END OF ADDENDUM NUMBER ONE (1)

CIVIL PLANS	
CCD PROJECT	23043.10
DATE ISSUED	August 6, 2024
DATE REVISED	August 15, 2024
#	1

CLINTON PARKS - PHASE I
 CITY OF CLINTON
 TRACEWAY PARKS & KIDS TOWNE PARK

DRAWING NO.
C001R1
GENERAL NOTES
AND SHEET INDEX

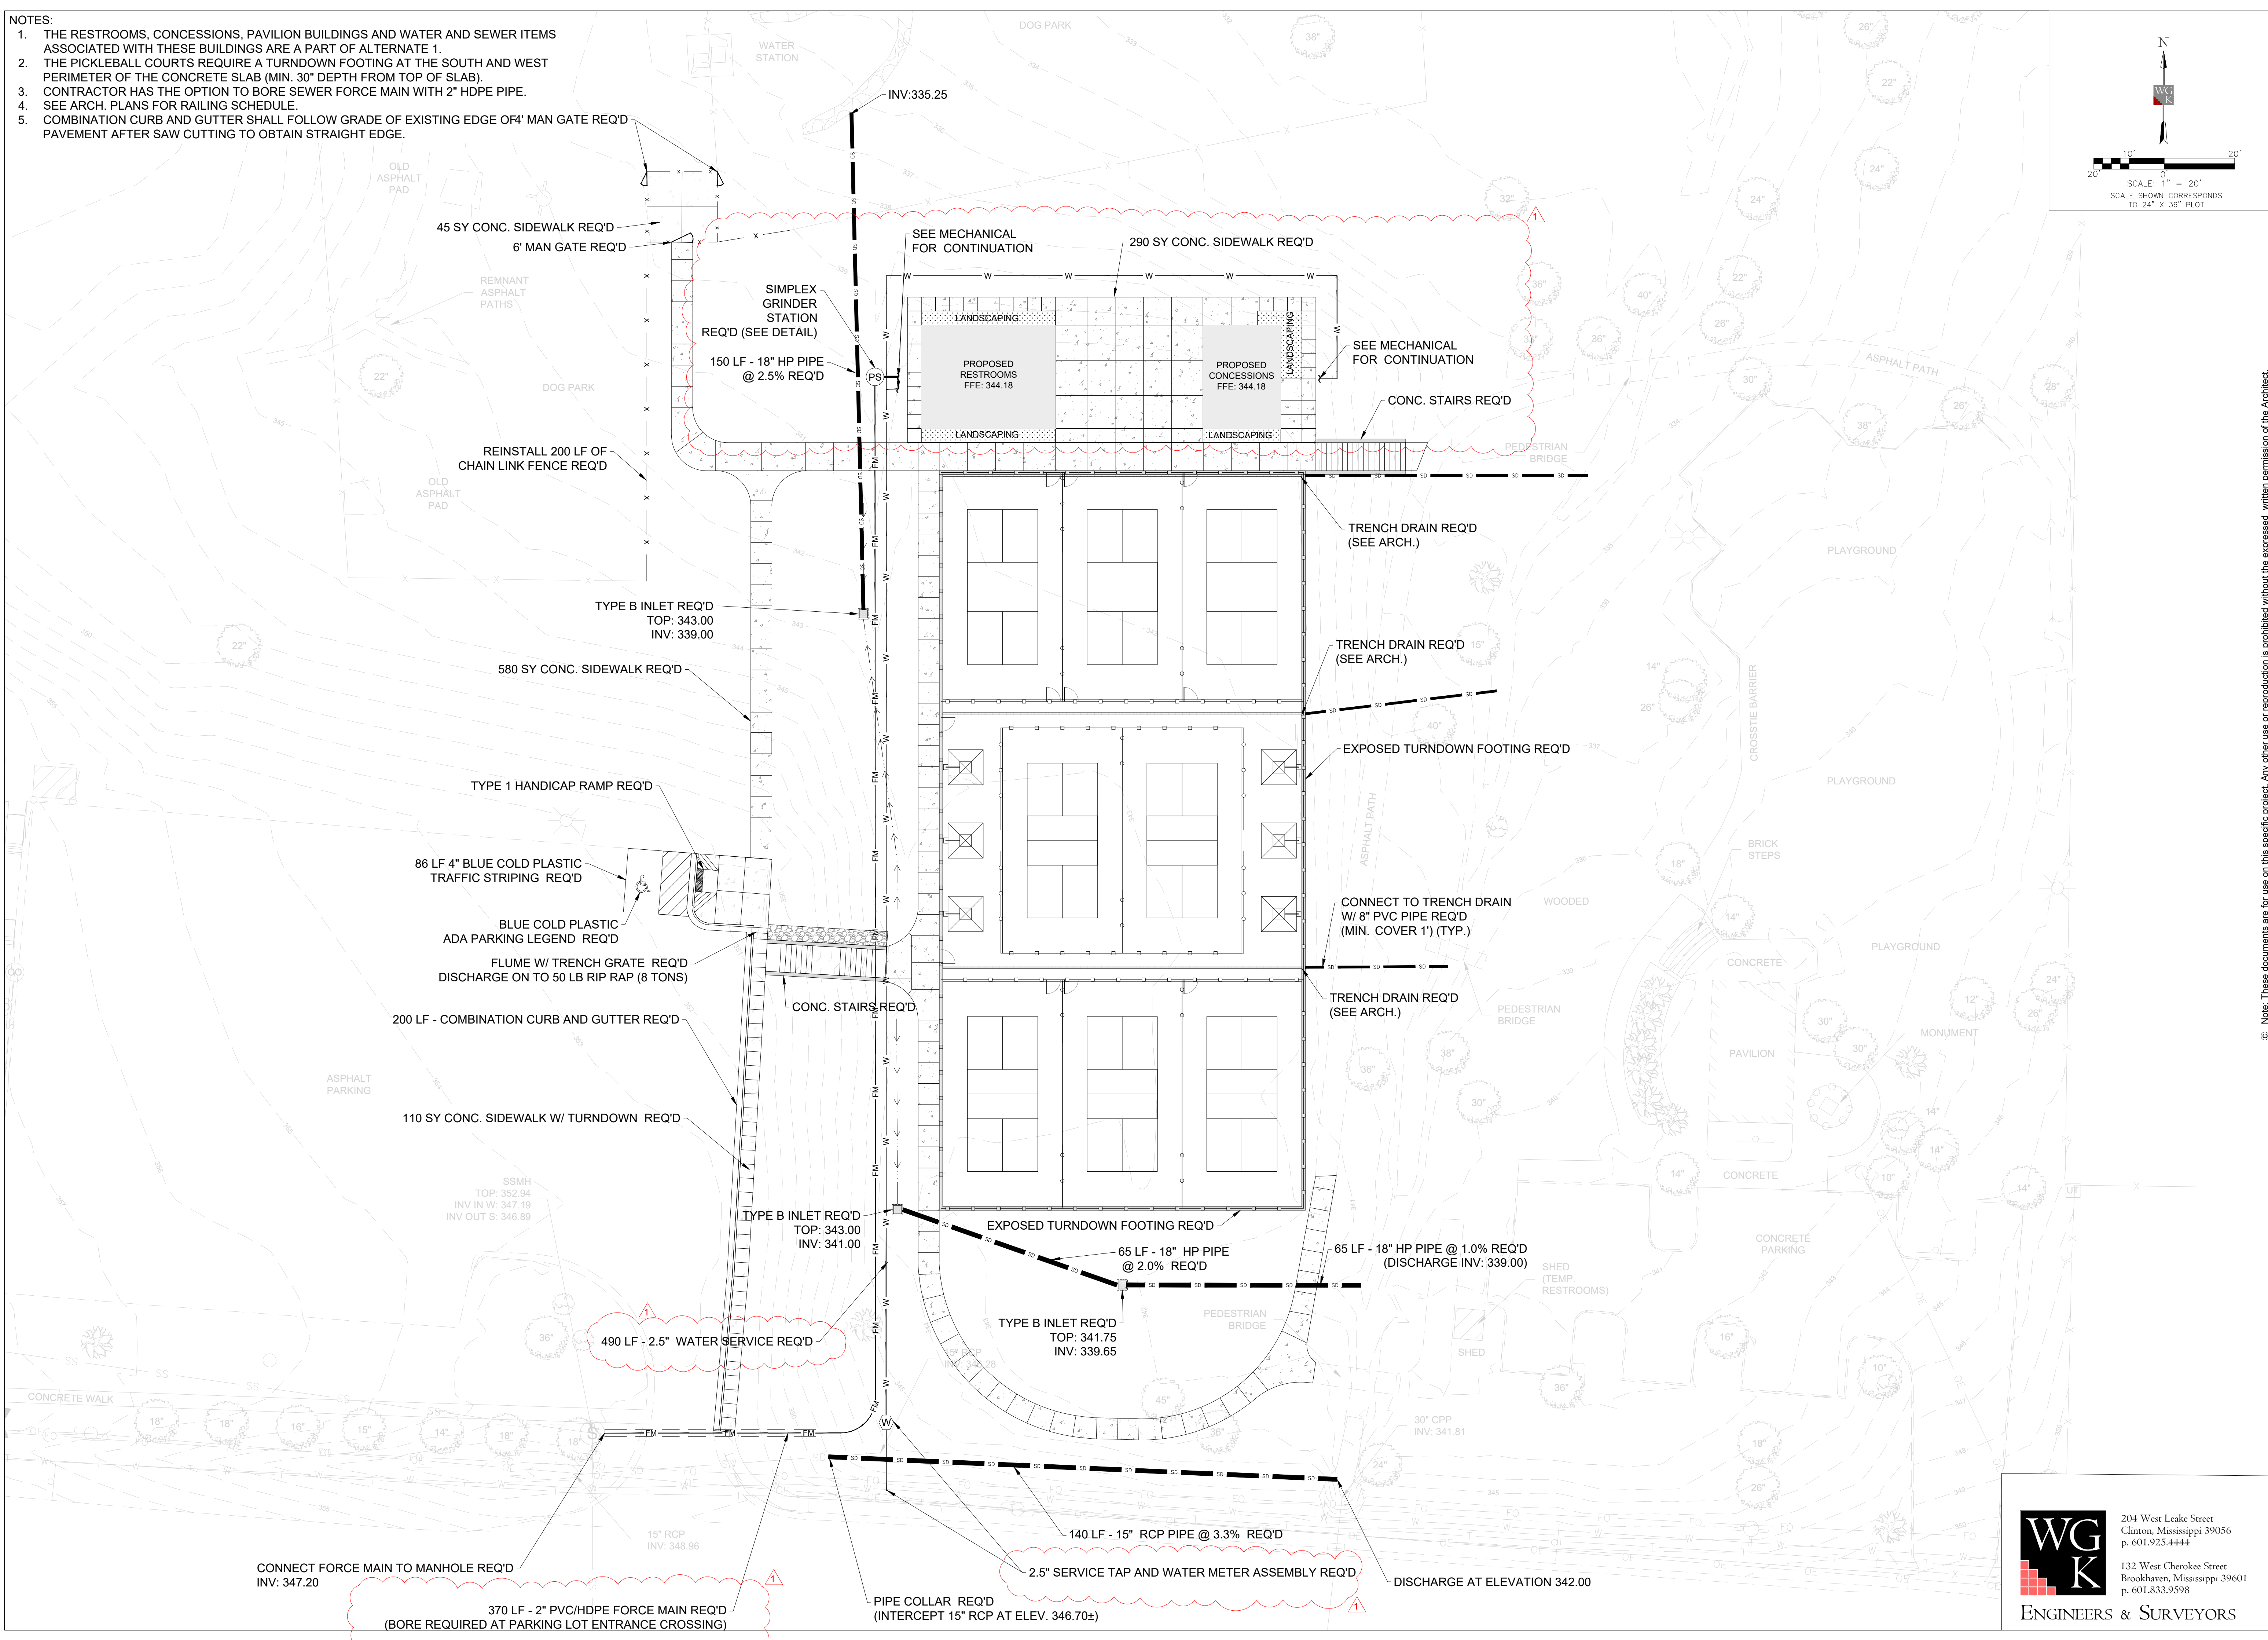
6. **DRAWING C001, GENERAL NOTES** – Replace with attached C001 R1 dated as revised August 15, 2024.
7. **DRAWING C102, KIDS TOWNE PARK SITE PLAN** – Replace with attached C102 R1 dated as revised August 15, 2024.

DRAWING NO.
C201R1
SOCCER ROW RESTROOMS AND CONCESSIONS SITE PLAN

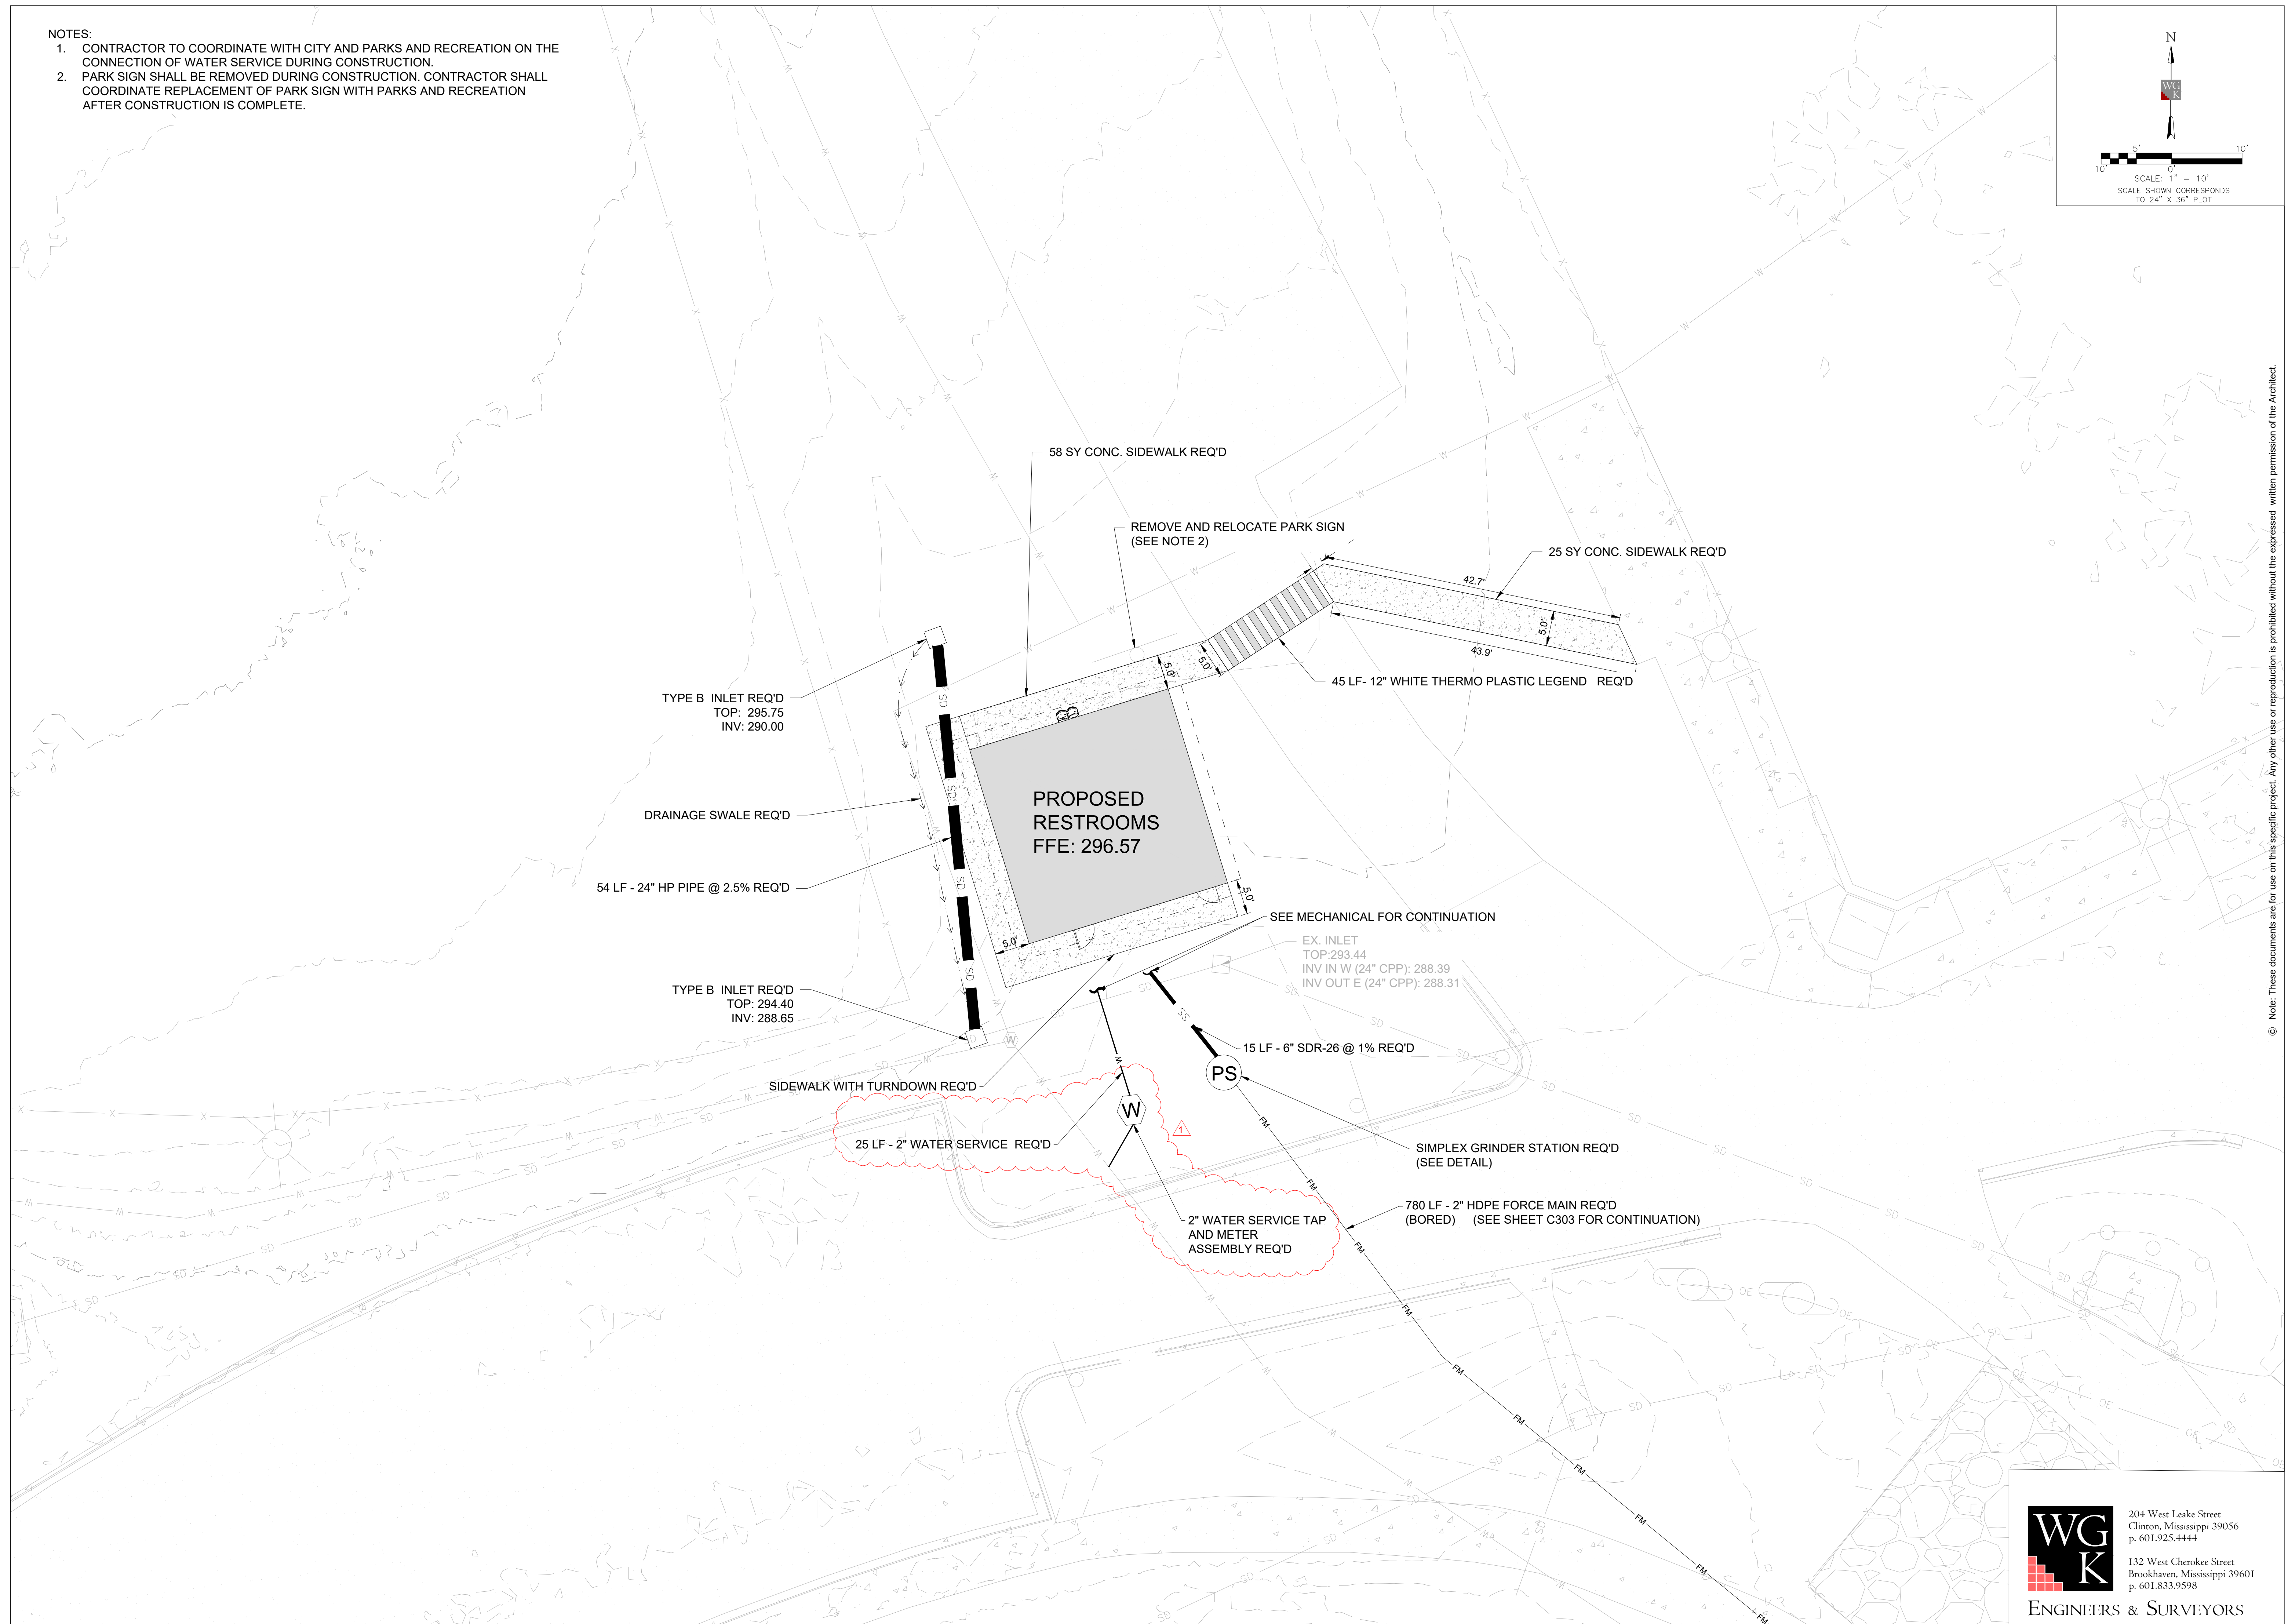
8. **DRAWING C201, SOCCER ROW SITE PLAN** – Replace with attached C201 R1 dated as revised August 15, 2024.
9. **DRAWING C301, BB #5 & BB #6 RESTROOMS SITE PLAN** – Replace with attached C301 R1 dated as revised August 15, 2024.

1 TOWNE PARK BASE BID HARDSCAPE PLAN
 Scale: 1" = 20'

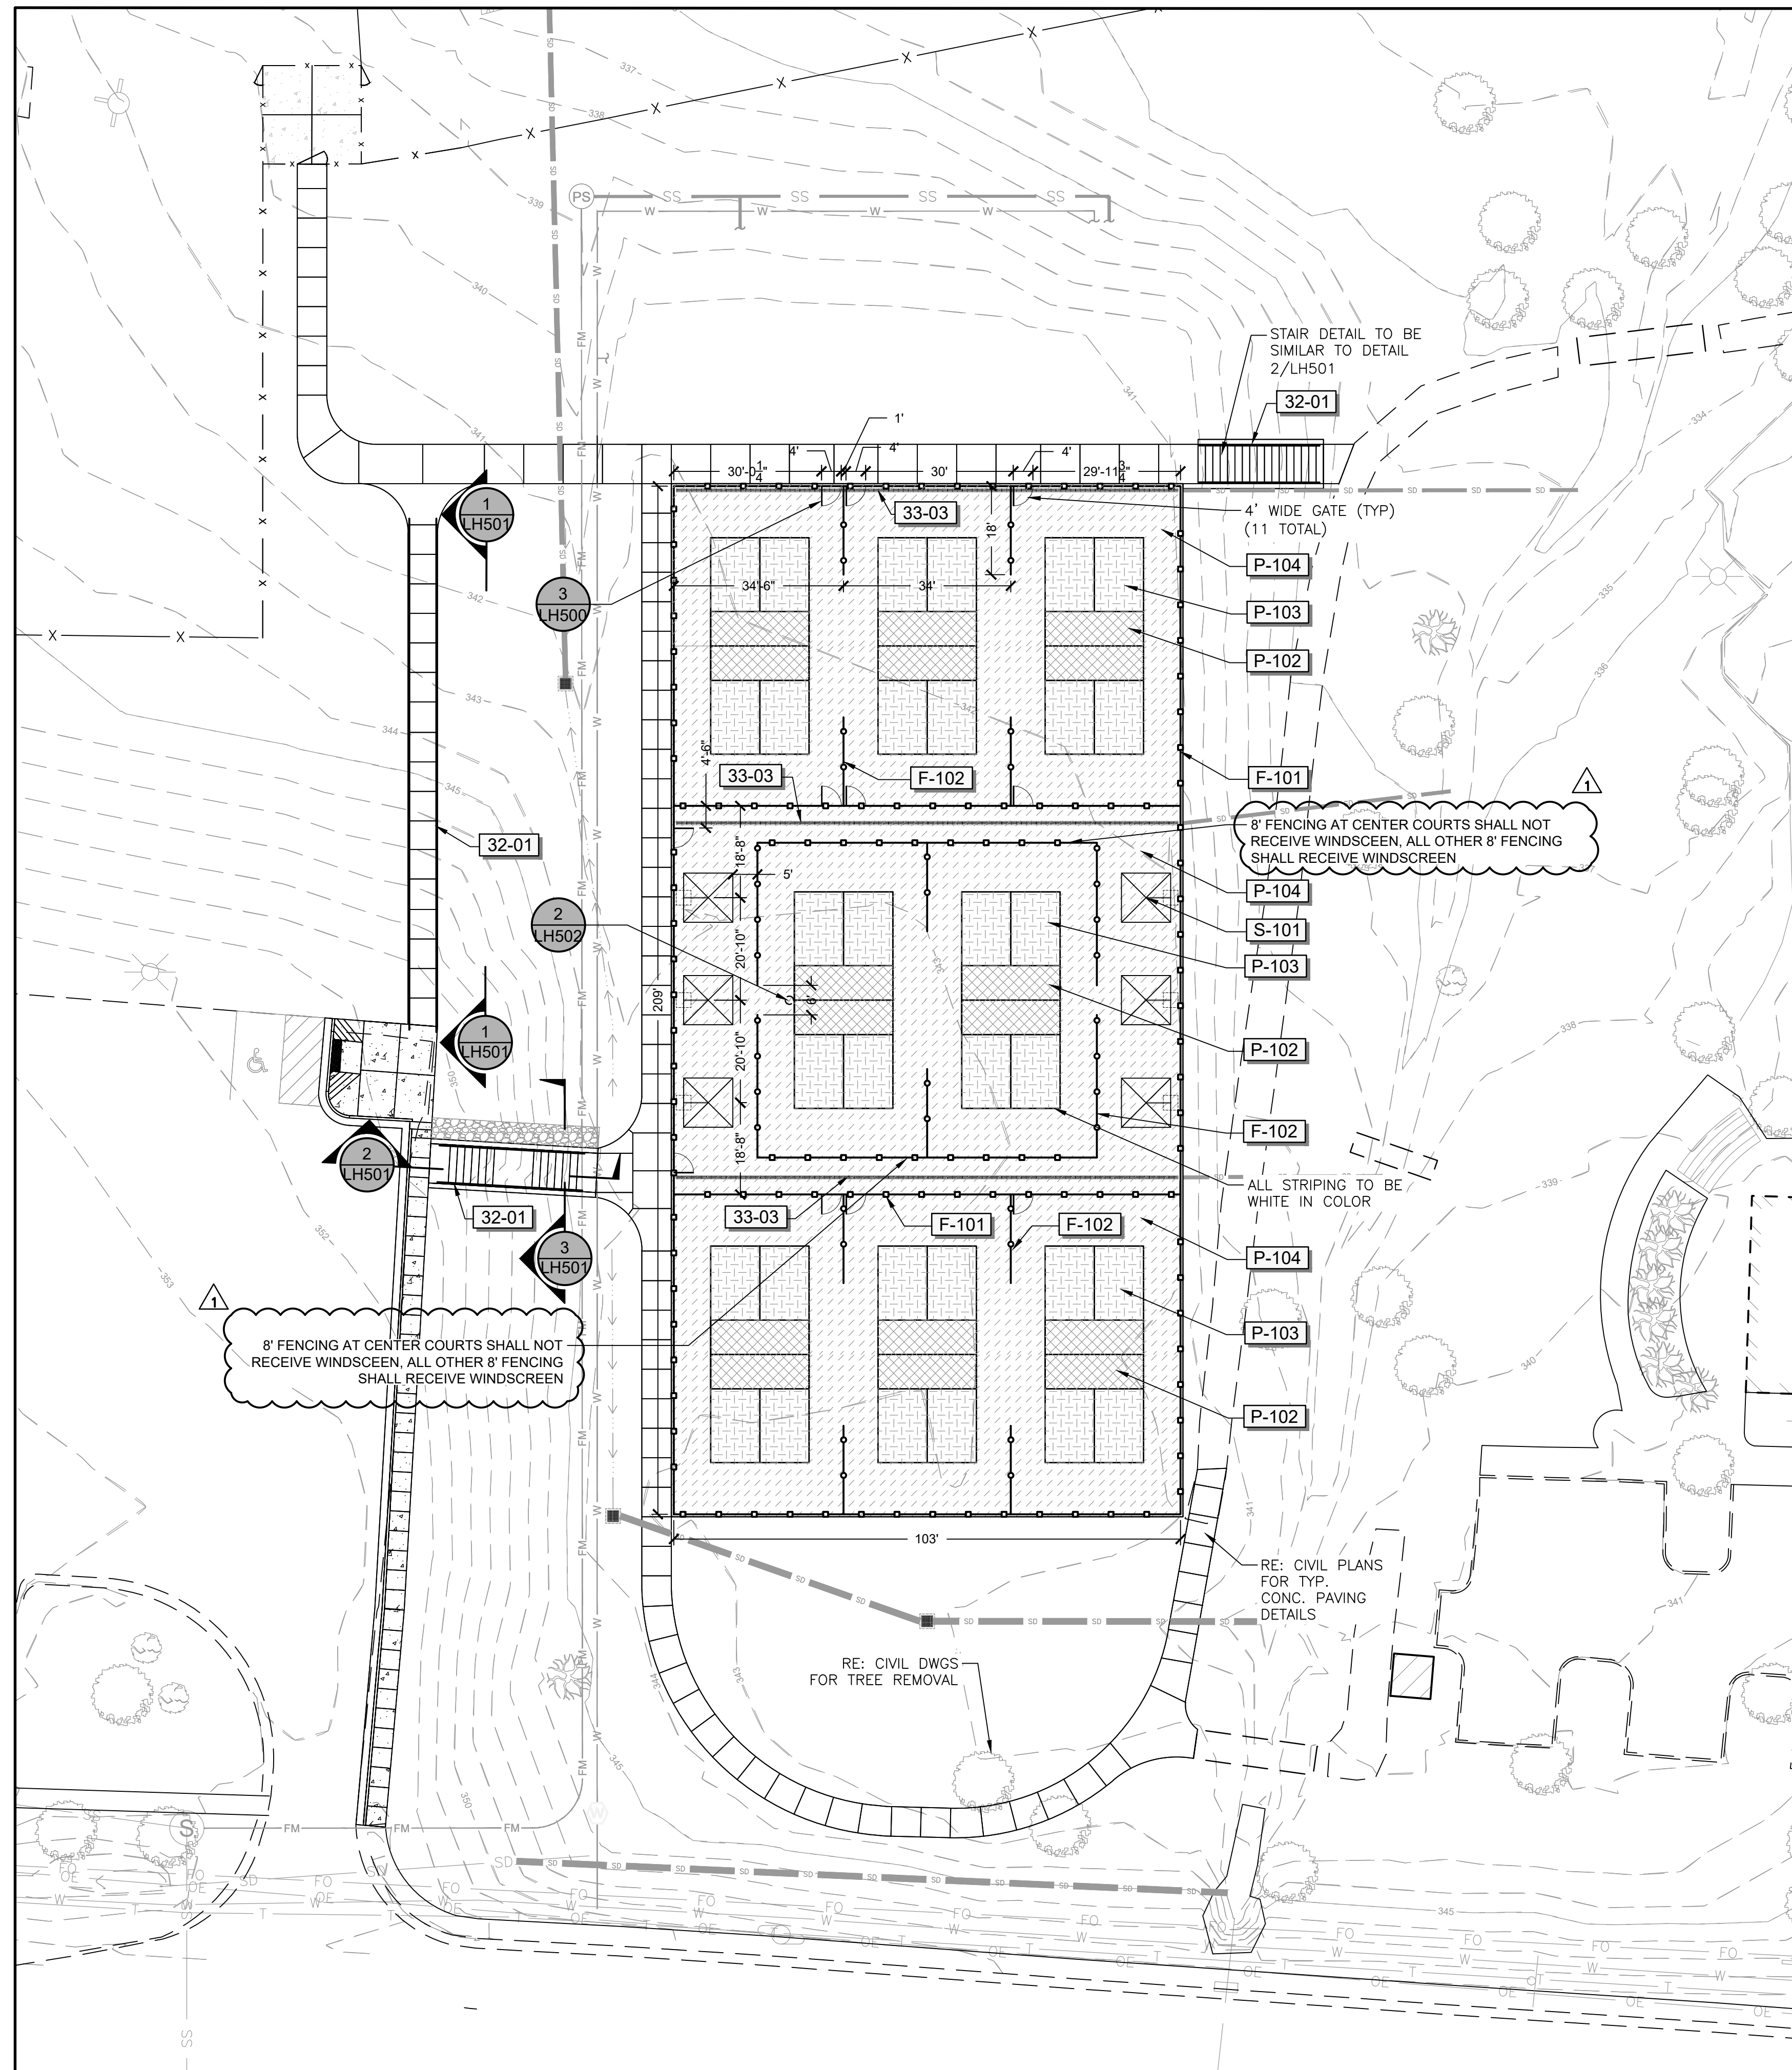
10. **DRAWING C306, BB#10 RESTROOMS SITE PLAN** – Replace with C306 R1 dated as revised August 15, 2024.
11. **DRAWING LH100, TOWNE PARK BASE BID HARDSCAPE PLAN** – Replace with attached LH100 R1 dated as revised August 15, 2024.
